# CHEM-NUCLEAR SYSTEMS, INC.

July 16, 1985

(b) CNSI Topical Report, "CNSI-WF-C-01-NP,10) CFR 61 Waste Form  
Certification - Cement"

ANSWERS TO U.S.N.R.C. QUESTIONS ON REV 1,  
CNSI-WF-C-01-NP TITLE 10 CFR 61,  
WASTE FORM CERTIFICATION--CEMENT

STRUCTURAL ANALYSIS OF CONCRETE RADWASTE CONTAINER  
UNDER BURIAL CONDITIONS

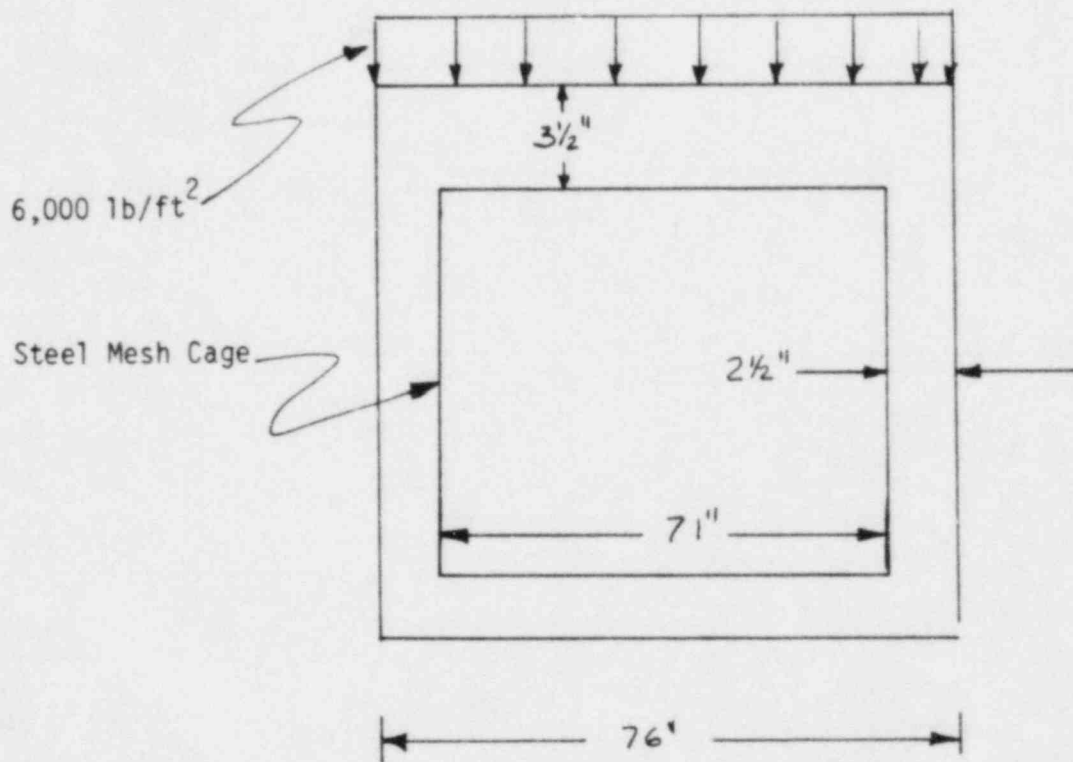
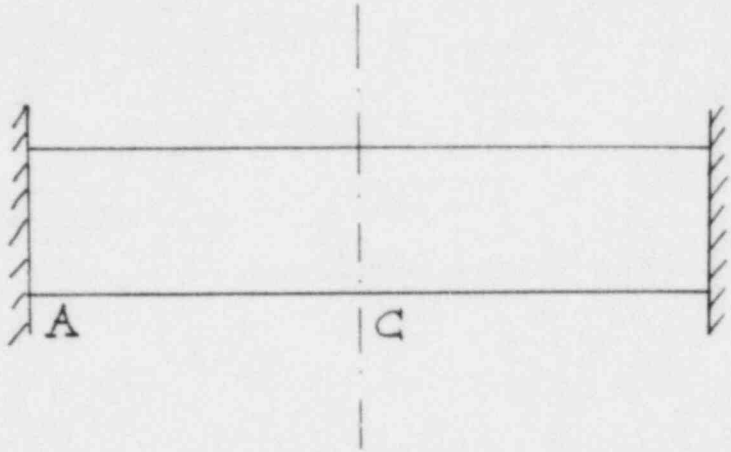
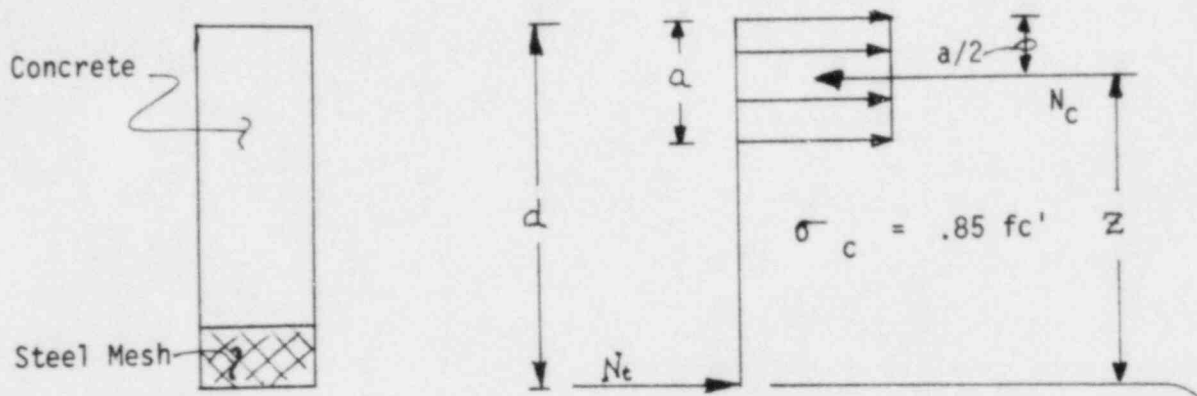
- a) Assuming that no support may be credited to the filters or other media to be encapsulated, will the cement slab support the weight of earth overburden?
- b) Is leach test data available for the in-situ formula? Are leach indices for the in-situ formula comparable to other waste formulas?

A4. a) It has been shown that the structural strength incorporated into the current design is sufficient to support the maximum expected loads for the largest container (14-195 Liner). The maximum span for that container is 71 inches of cement with a minimum thickness of 3 1/2 inches, and contains two layers of 3/4" gage 9 steel mesh. This lid is sufficient to support up to 50 ft of 120 lb/ft<sup>3</sup> soil overburden. (See Attachment 1)

The analysis shows that with a lid thickness of concrete (3.50 inches) and the existing layers of wire, the allowable stresses are not exceeded and the container may be buried for an indefinite period without failure of the lid due to the soil loading.

Therefore present design, having 3-1/2 inch concrete thickness with 0.075 inch of steel reinforcing, meets the above criteria.

ATTACHMENT 4

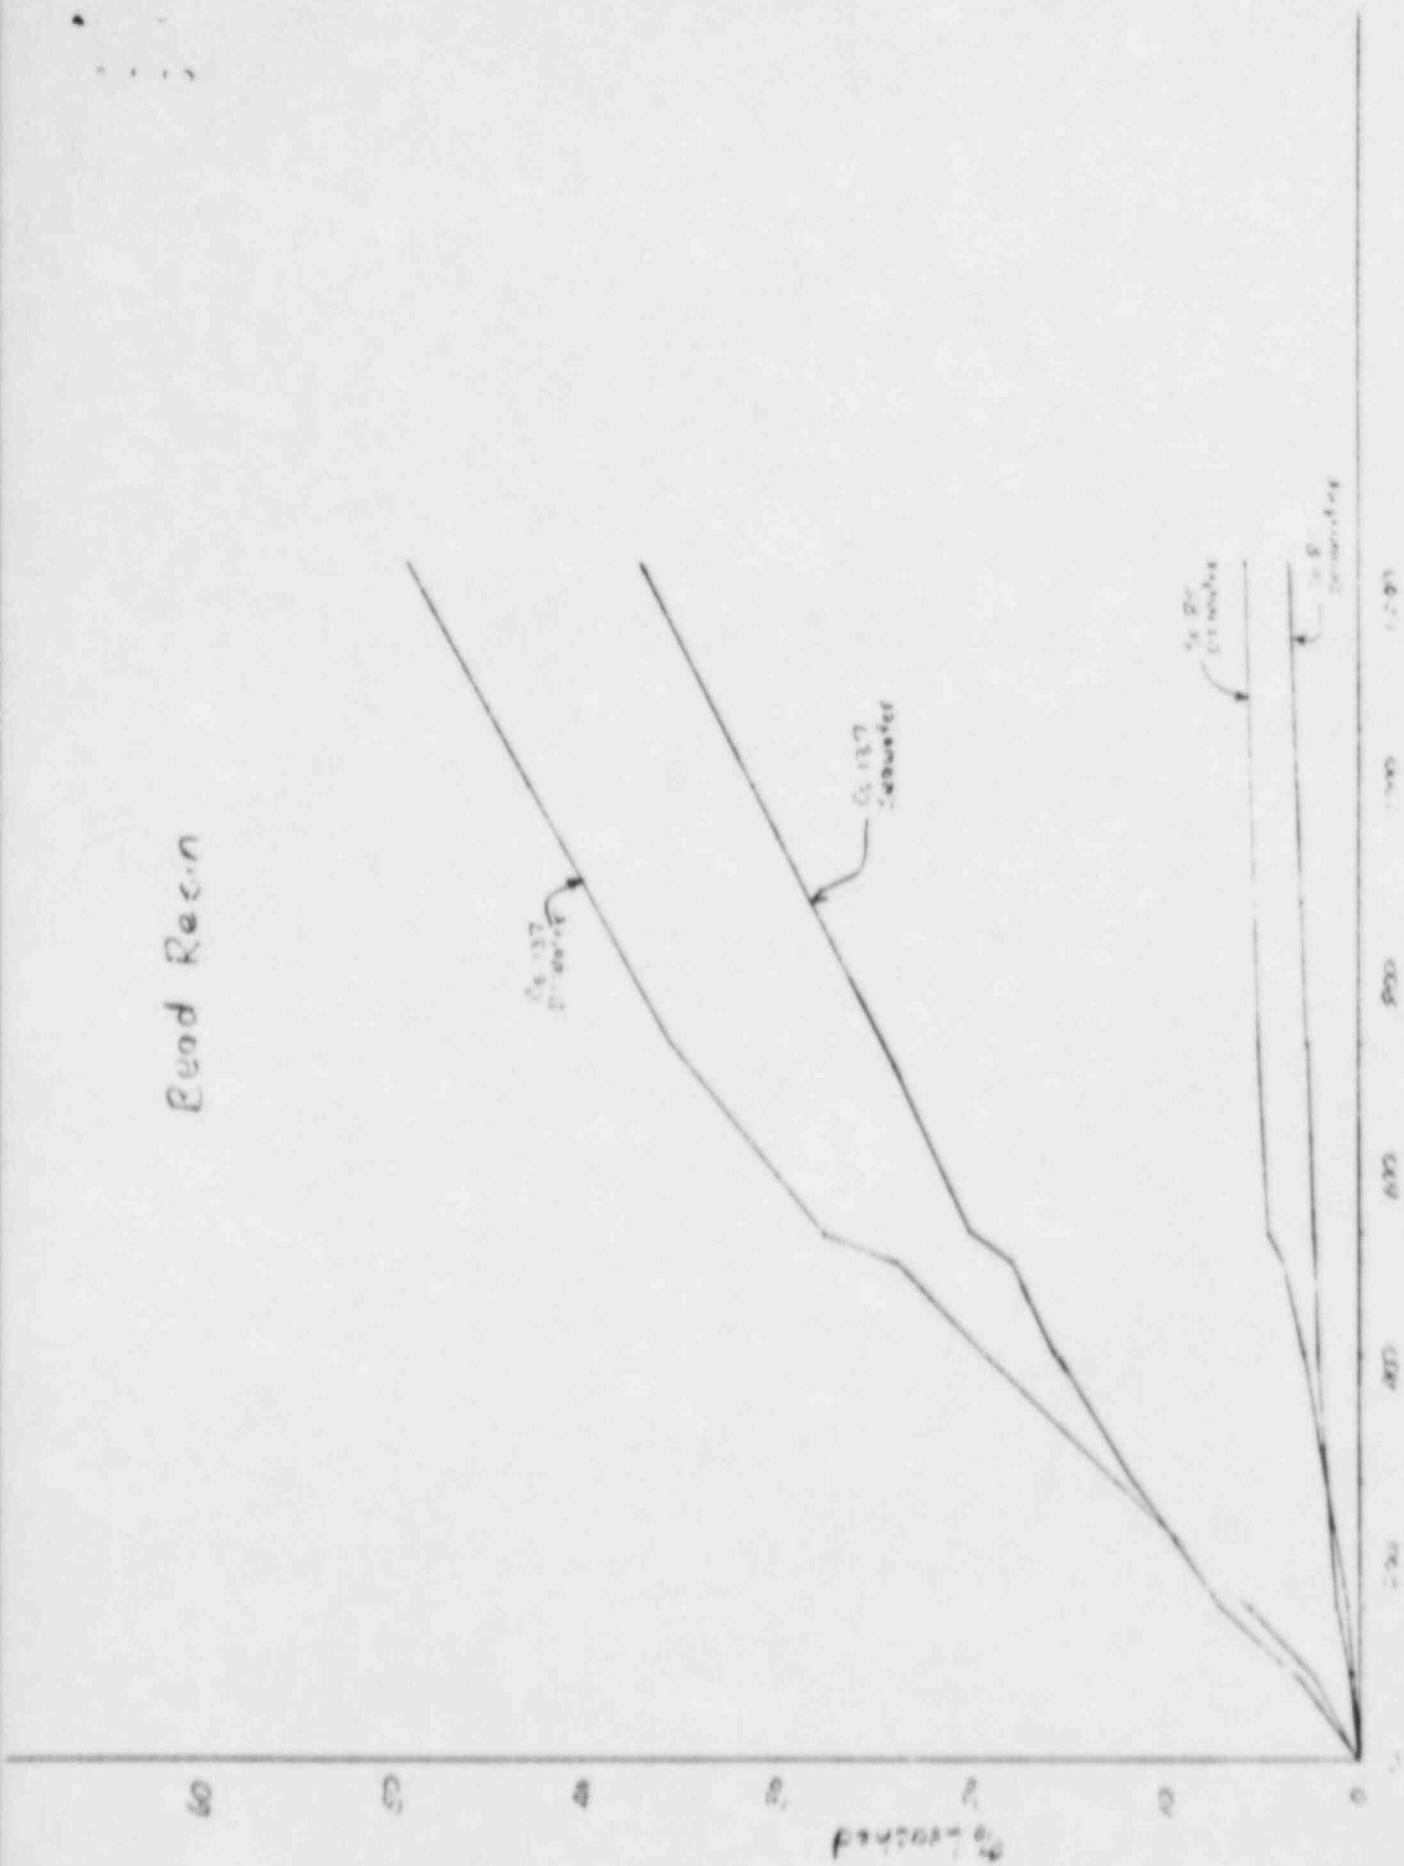
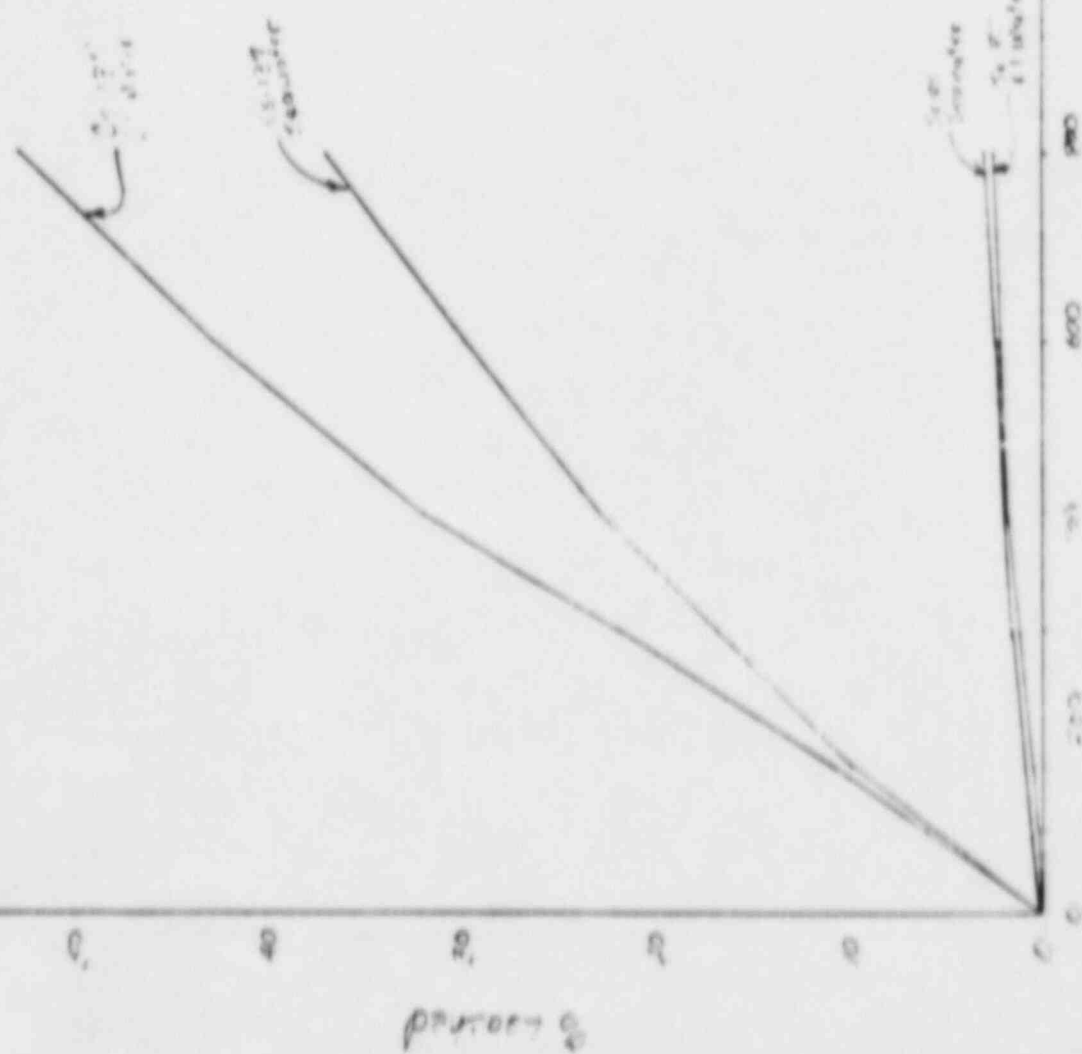
Q14. Please provide all data for leach tests of various leachants. Why was sea water not used?

A14. In lieu of performing tests using synthesized sea water as a leachant, CNSI decided to submit data generated in 1981 on a now obsolete formula which used leachants of various pH values. These tests used Cs-137, Co-60, Sr-85, and Ce-144, and showed that varying the pH did not affect the leach rate. Although the Technical Position on Waste Form states that "additional testing using other leachants specified in ANS 16.1 should also be performed," CNSI believed these data would be sufficient to fulfill the intended purpose of testing various leachants, "to confirm the solidification agents' leach resistance in other leachant media."

Presently, Chem-Nuclear has conducted comparative leach and deionized water tests using synthesized sea water on resin bead and boric acid formulas. Higher leach indices were obtained for the sea water leachant in each test.

As a result of these tests, CNSI believes that demineralized water adequately defines a solidification agent's leaching behavior. (See Attachment 4).
